ArcWriter[®]

Contactors Replacement

Field Service Bulletin
(P/N 804450)

Revision 0 – July, 2002

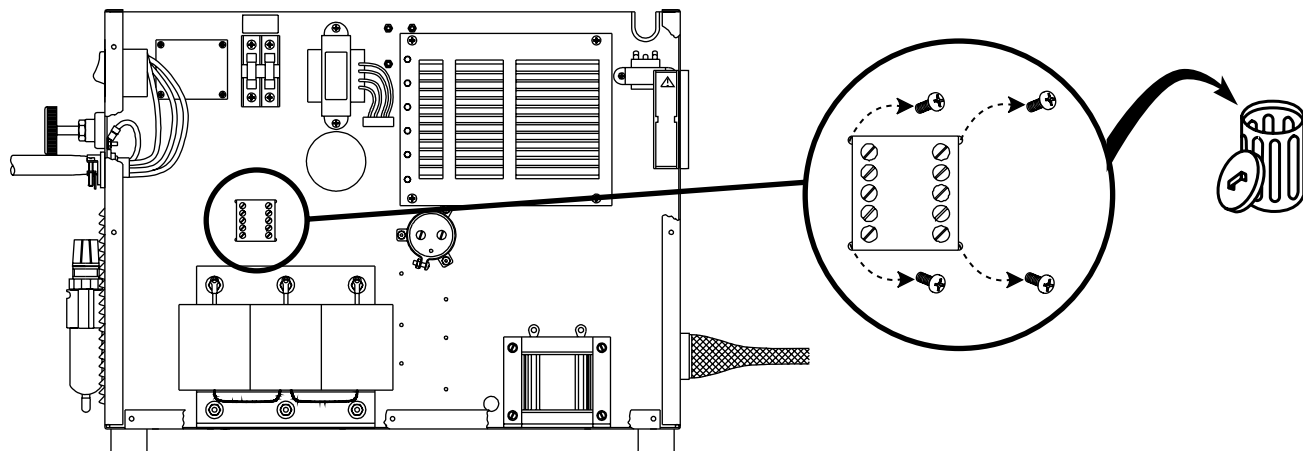
- ② Locate contactor and disconnect all wires.

- ③ Remove screws (4) and discard old contactor and screws.

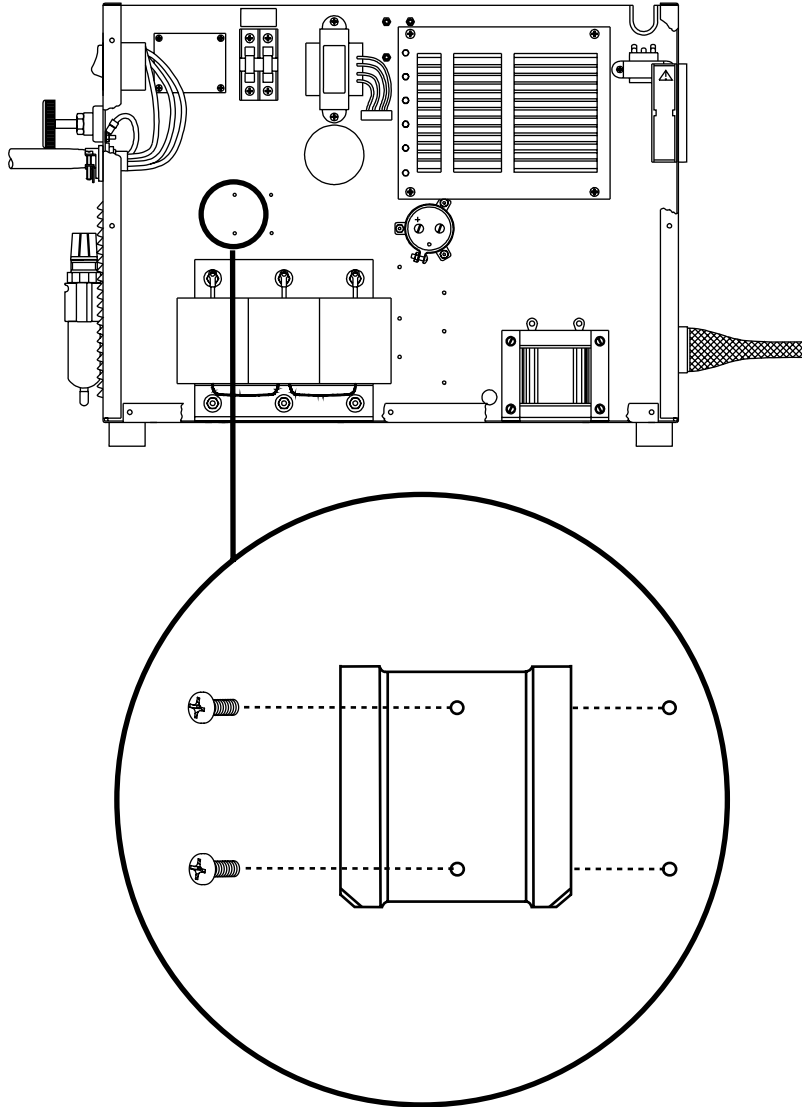
- ④ Use the 2 existing holes shown below and the 2 screws (075063) provided in this kit to install the DIN rail (104000).

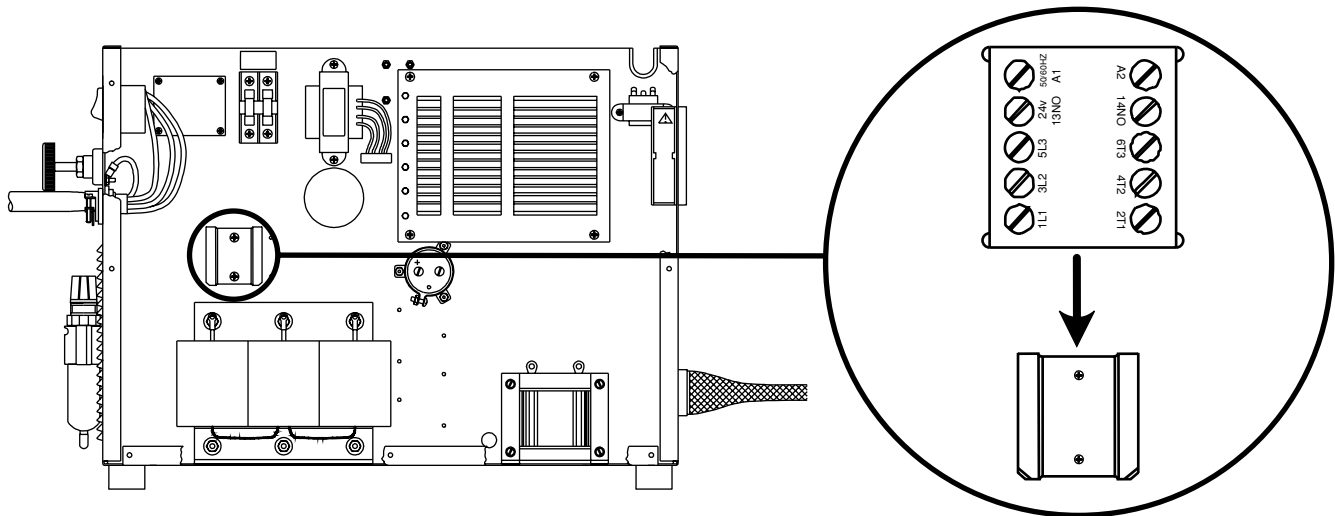
⑤ Slide new contactor on DIN rail. See figure below for proper orientation.
